Decision Maker: **Environment Portfolio Holder**

Date: **15th March 2018**

Title: **LOWER SYDENHAM TO BROMLEY QUIETWAY PUBLIC
CONSULTATION REPORT AND FINAL PROPOSALS**

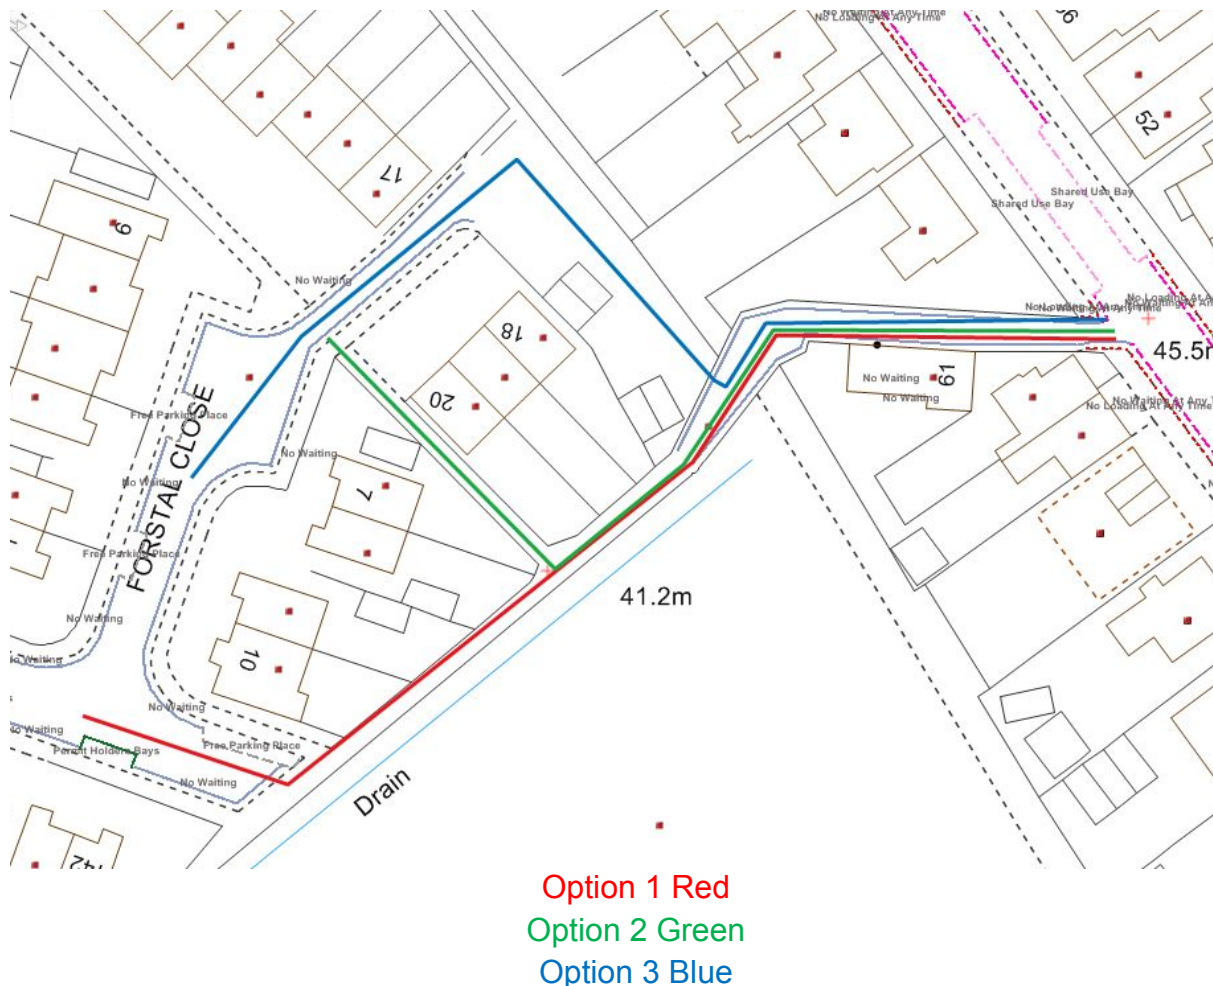
Worsley Bridge Road shared path- Implement as proposed with minor modifications based on consultation comments
